ACCESSION NBR: 8711050039      DOC. DATE: 87/10/29      NOTARIZED: NO      DOCKET #  
 FACIL: 50-269 Oconee Nuclear Station, Unit 1, Duke Power Co.      05000269  
 AUTH. NAME      AUTHOR AFFILIATION  
 TUCKER, H. B.      Duke Power Co.  
 RECIP. NAME      RECIPIENT AFFILIATION  
                                  Document Control Branch (Document Control Desk)

SUBJECT: Forwards requests for relief from certain inservice insp testing, per ASME Boiler & Pressure Vessel Code, Section XI w/ addenda through Winter 1980, for review & approval for 871103 startup. Testing impractical following repair.

Subject: Oconee Nuclear Station, Unit 1  
Docket Nos. 50-269  
Request for Relief

SHEET 1 (PART 1 OF 2) ADDED WELDS

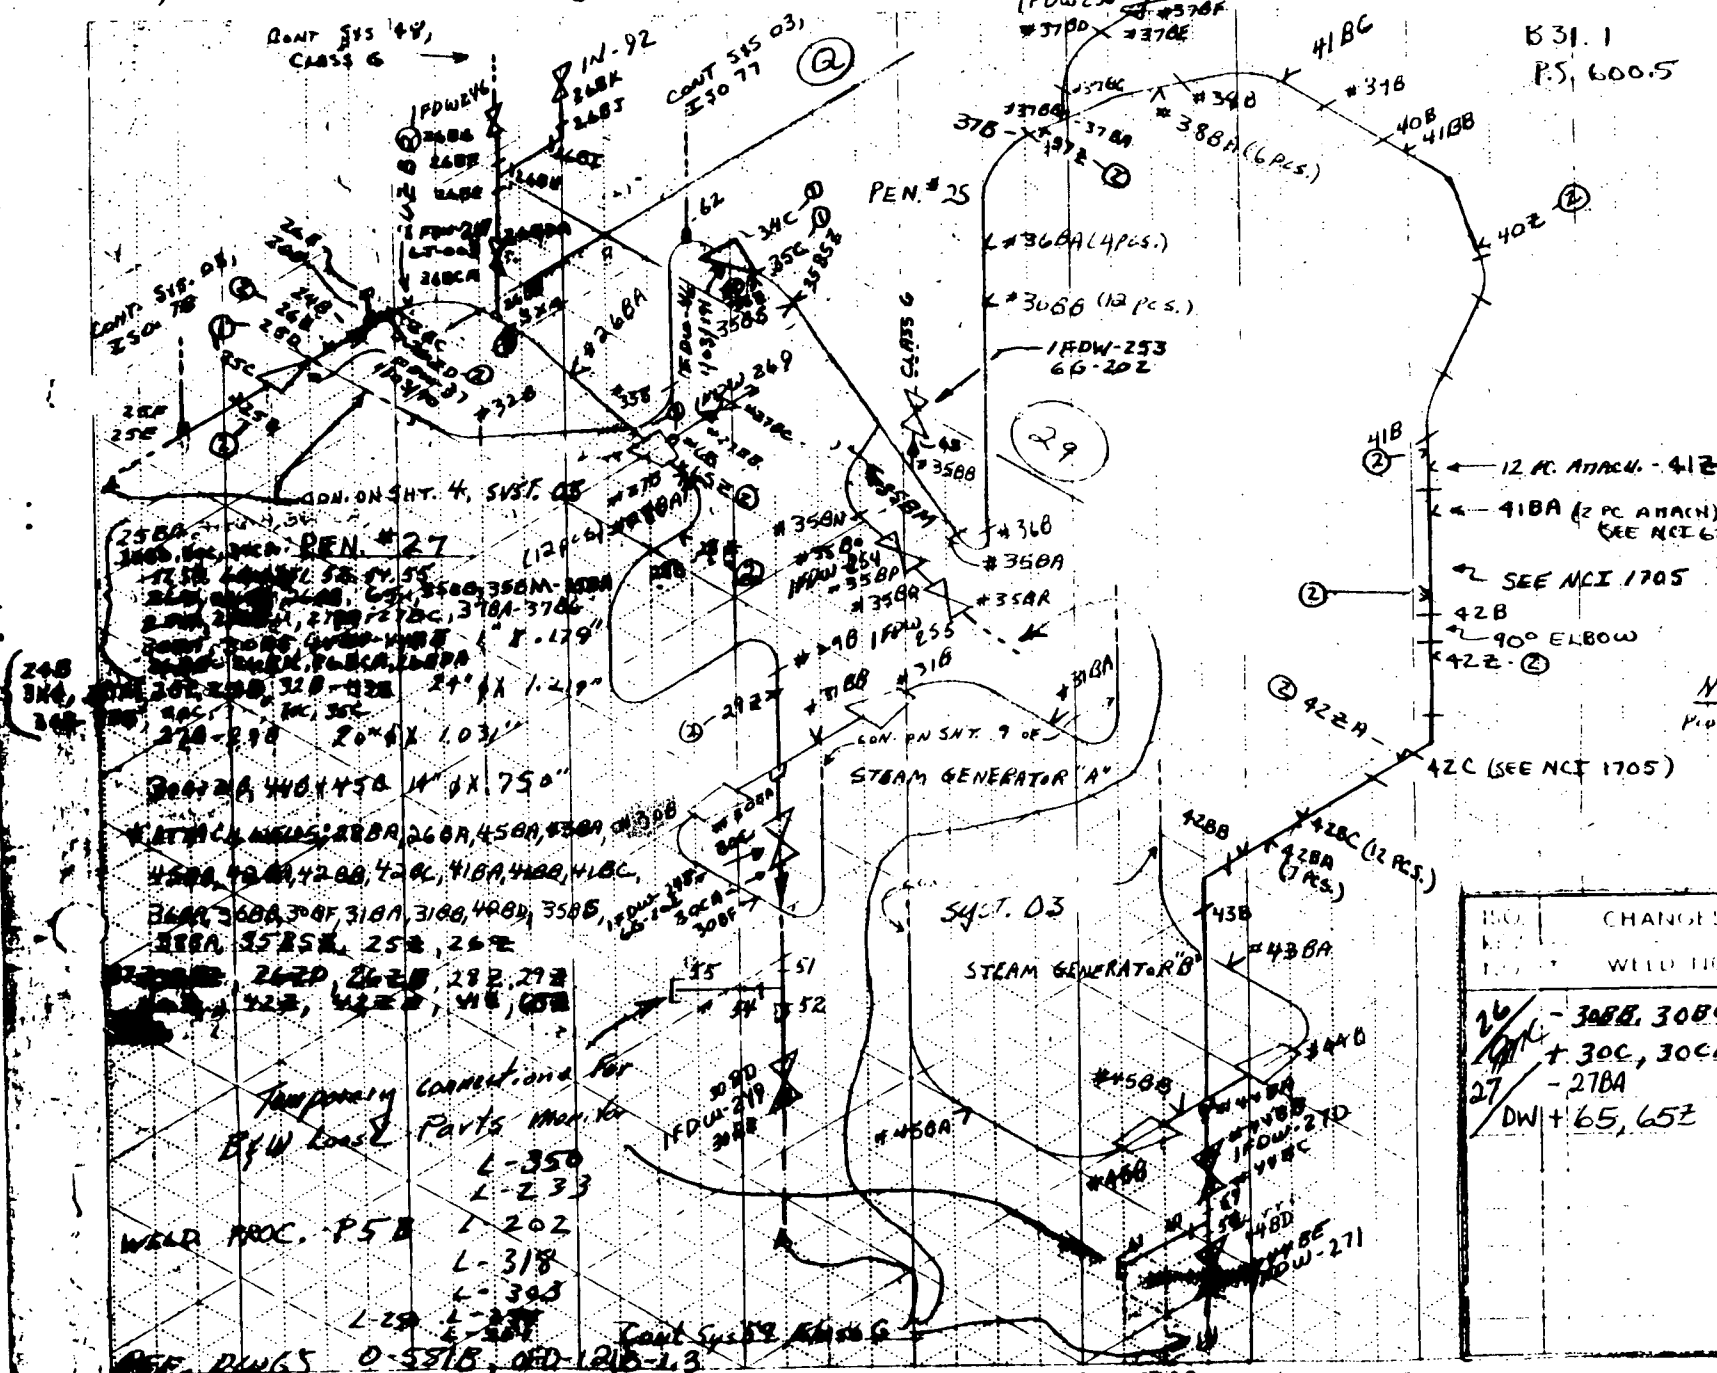
- (a) Name and Number: Feedwater System Weld No. 30B (see attached sketch)
- (b) Function: Provides feedwater to the steam generators
- (c) ISI Class/Duke Class: ISI Class C/Duke Class F
- (d) Valve Category: N/A

ASME Boiler and Pressure Vessel Code Section XI, 1980 Edition (with Addenda through Winter 1980) paragraph IWA-5214 which requires a system pressure test per IWA-5211.

Performing the required pressure test would require a hydrostatic test of the Once Through Steam Generator (OTSG) and associated piping. Hydrostatic testing of the OTSG would require filling the Main Steam lines with water and would unnecessarily place additional hydrostatic test cycles on the OTSG.

A VT-2 inspection and a radiograph will be performed on the subject weld.

The alternate examination will be performed when the unit is in hot shutdown conditions during the current Unit 1 refueling outage (End of Cycle 10). In addition, the weld will be hydrostatically tested as part of the 10 year Inservice Inspection of feedwater, OTSG, and Main Steam.
